## ERRATA

Engineering Decision Analysis Company, Inc., "Evaluations for 0.6g Ground Acceleration Case, Supplement No. 2 to 'Additional Investigations to Determine the Effects of Combined Vibratory Motions and Surface Rupture Offset Due to an Earthquake on the Postulated Verona Fault,' EDAC-117-253.01, Revision 1, Supplement 2, prepared for General Electric Company, 30 June 1980.

FIGURE 6. LOADING VS. CAPACITY

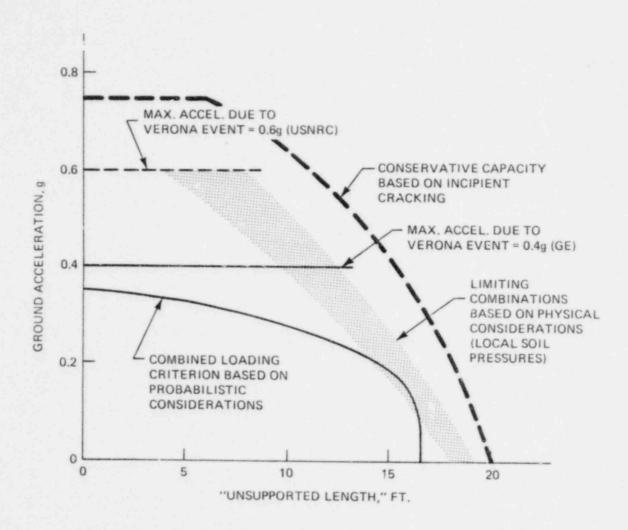
Please replace Figure 6 of Reference 1 with the Figure 6 attached to this errata sheet.
